Re: Cleanup Complete Determination – Former Municipal Shops Property

- Sitka Public Works Shop Fleet – Database ID #1993120020401
- Sitka Former Public Works – Database ID #2000120935601
- ADOTPF – Sitka Halibut Point Road Maintenance Station – Database ID #2000120009901

The Alaska Department of Environmental Conservation (ADEC) Contaminated Sites Program has reviewed file information for the referenced property, including the July 2007 *Final Cleanup Report* prepared by Carson Dorn, Inc. This letter documents the department's decision regarding site closure under 18 AAC 75 and 18 AAC 78 regulations.

Municipal Shops Property – View East

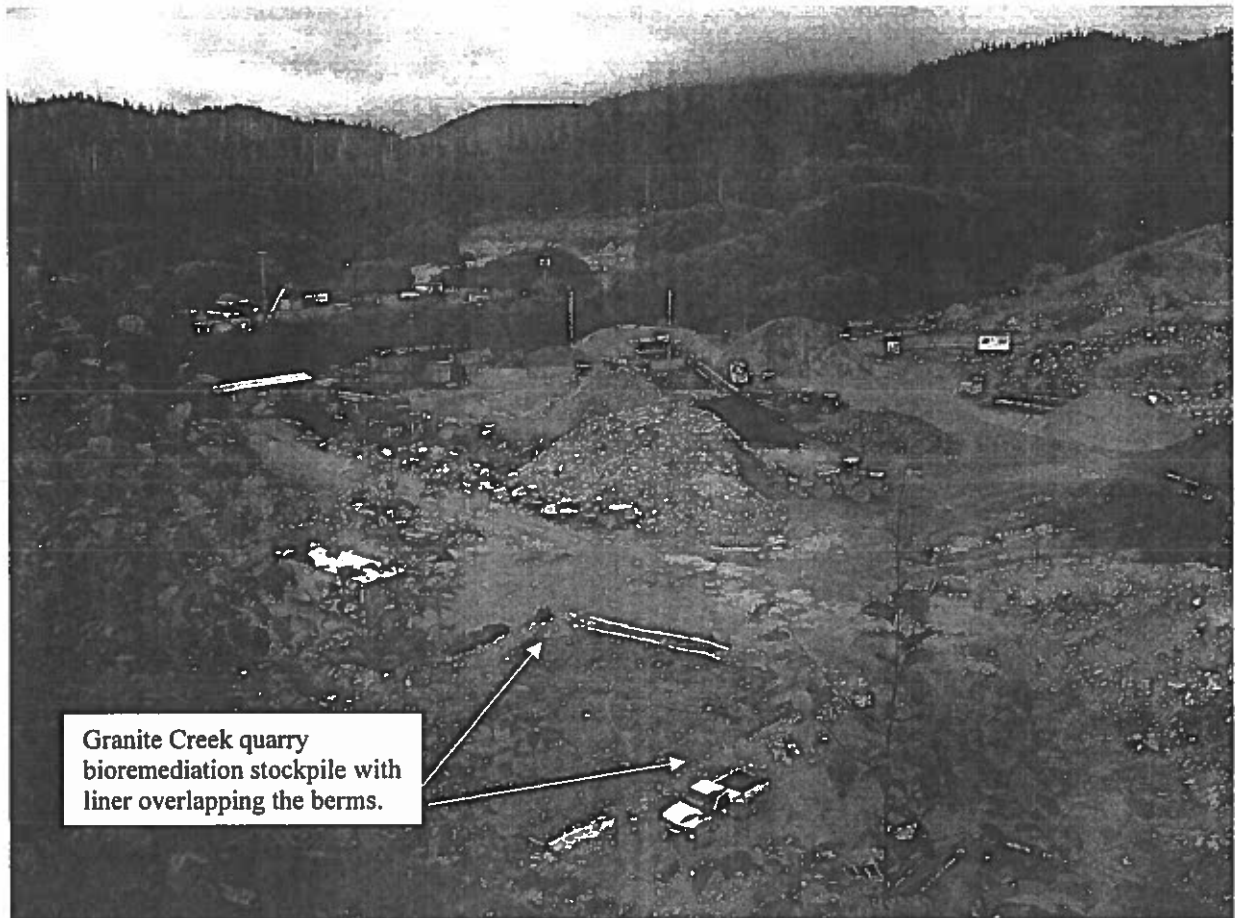
I conducted a final site inspection with CBS employee Mark Buggins on August 1, 2007. All structures have been

removed and the site has been leveled. Runoff water from the hillside has been diverted around the property through a drainage ditch where it then enters the storm drain system and flows through a culvert beneath Halibut Point Road. Surface water then flows into a small freshwater wetland and discharges into marine water. No leachate or petroleum sheen was observed in ditch water or the wetland during the inspection.
